ADDENDUM No. 5

Project	T.A. Blakelock H.S. Renovations - Phase 1	Project No.	2215A
Location	1160 Rebecca Street, Oakville, Ontario	Date of Issue	2023 04 04
Owner	Halton District School Board	File	2215/7.1.3

STRUCTURAL ADDENDUM No. 1

Drawing Title: COVER PAGE, **GENERAL NOTES & DETAILS**

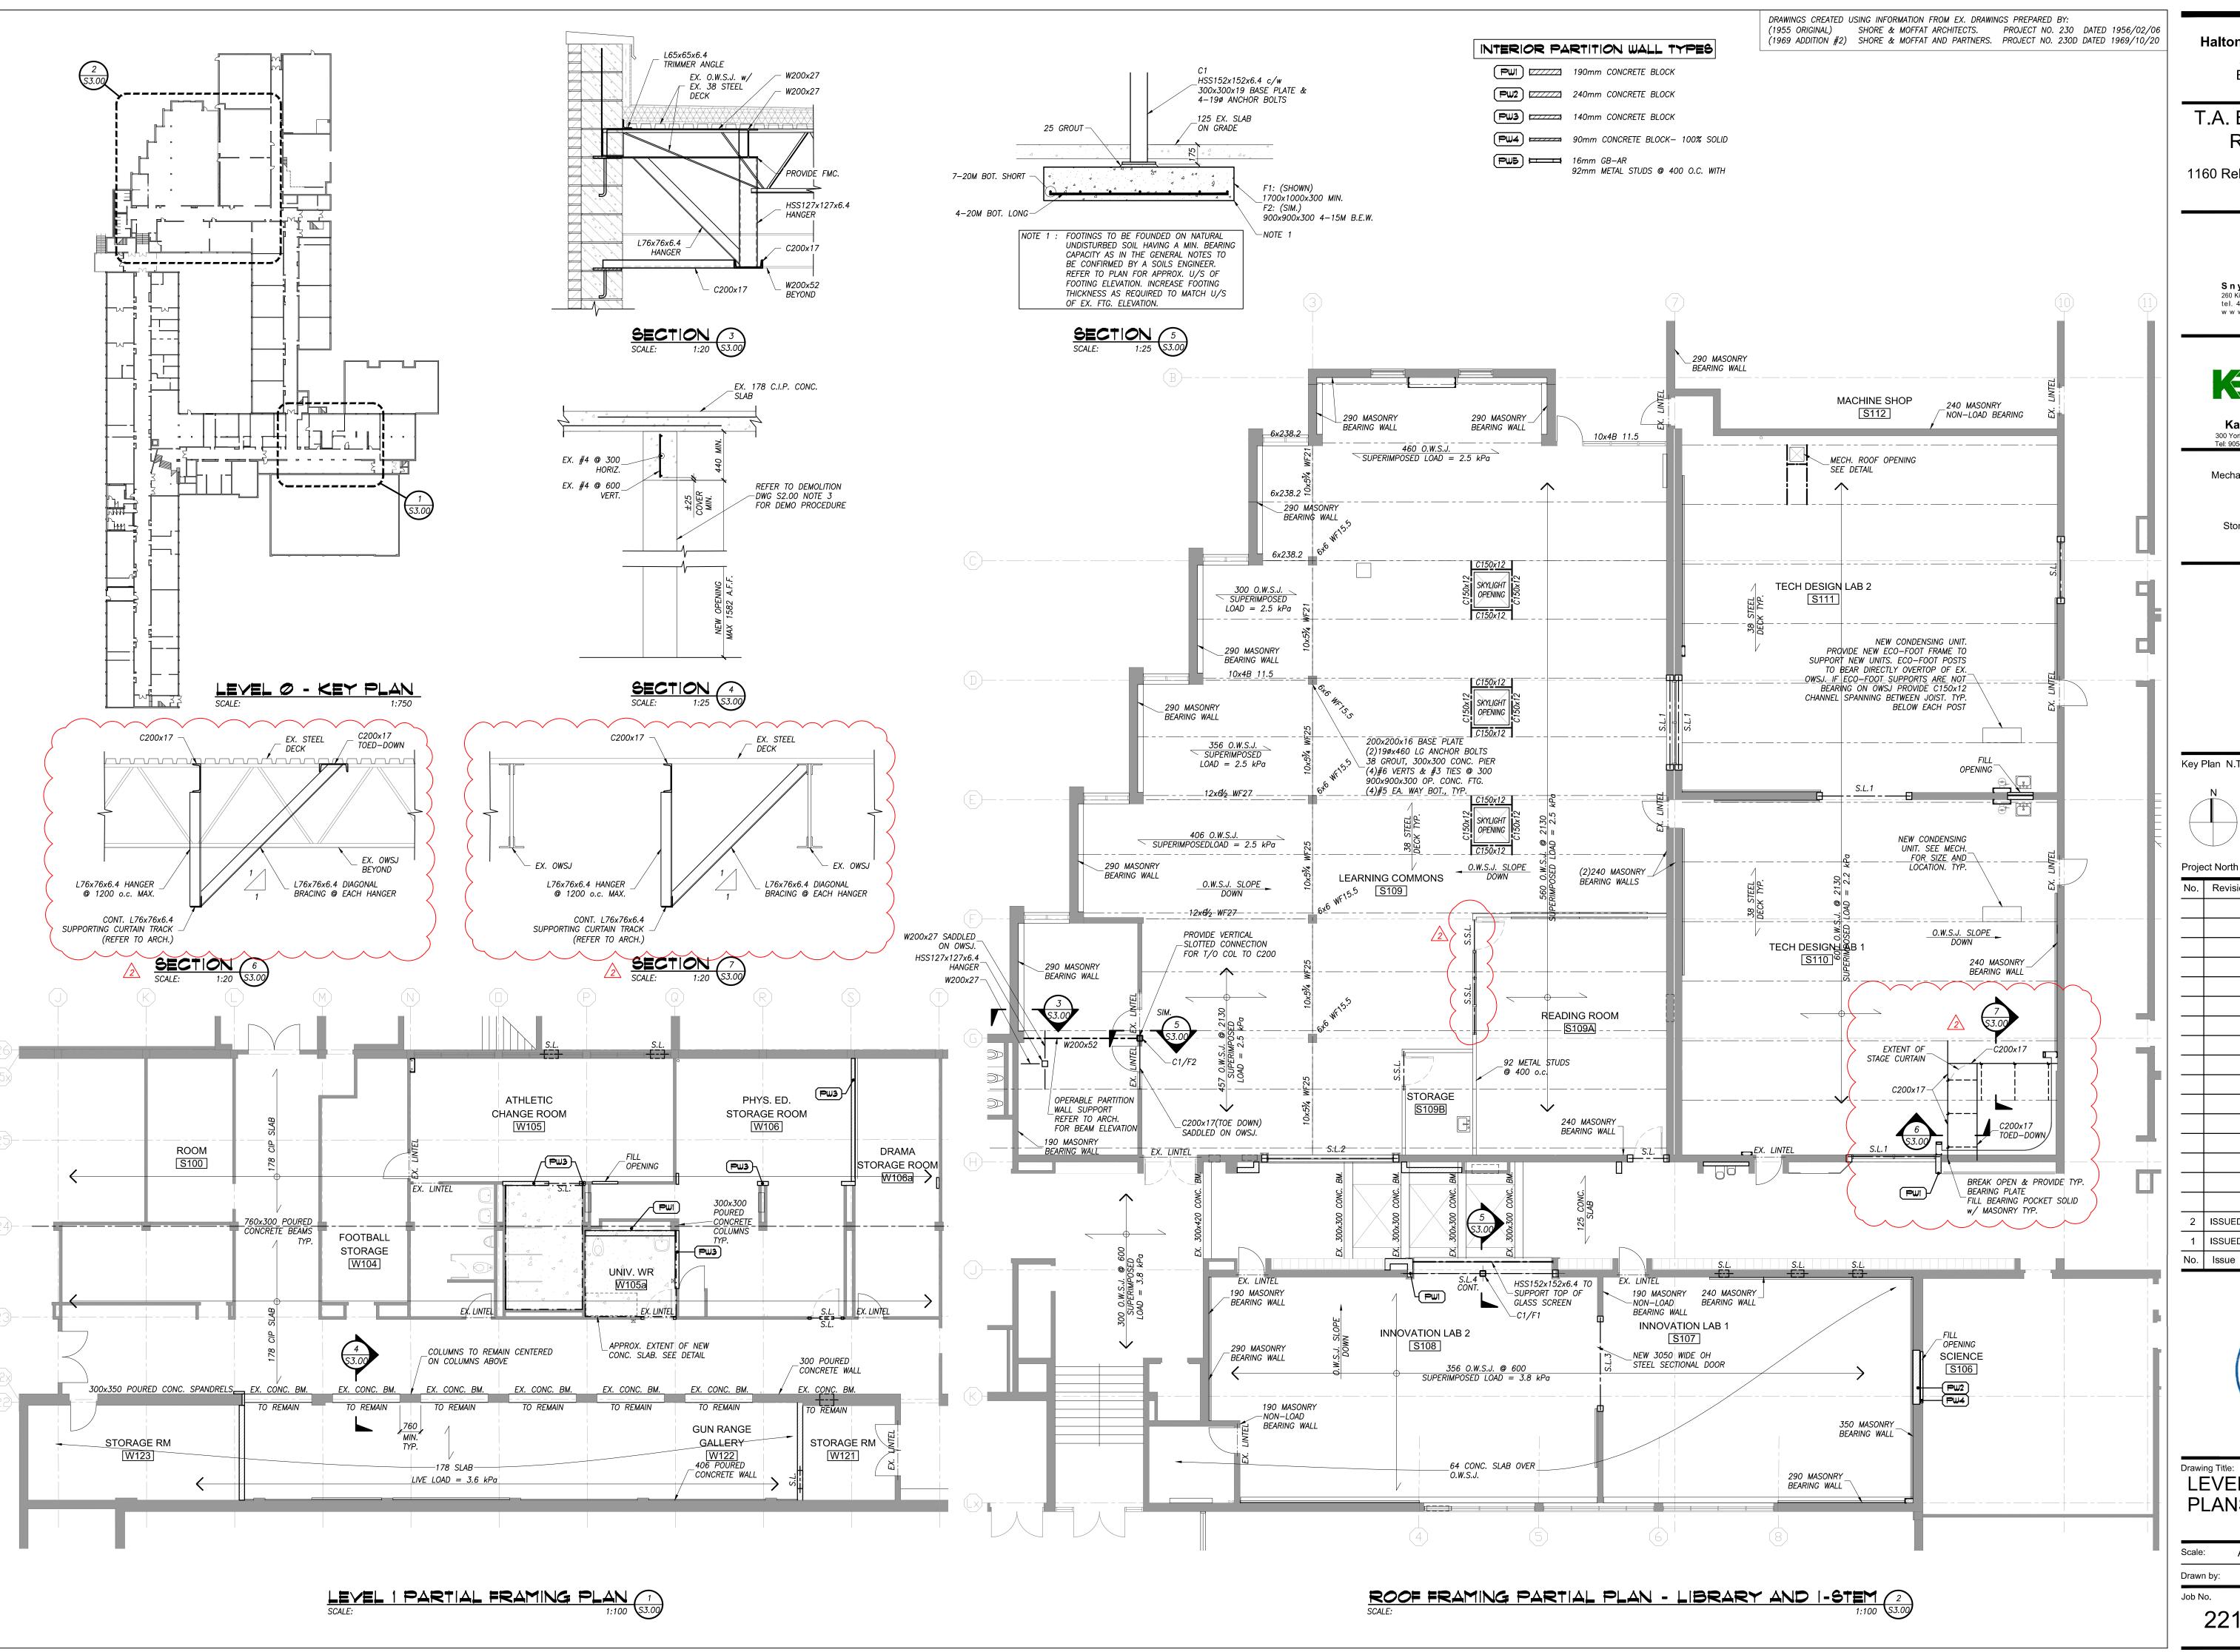
- A. <u>Drawing So.o1:</u>
 - a. Steel stud header and jamb schedule updated.
 - b. Submittals notes updated.
- B. Drawing S₃.00:
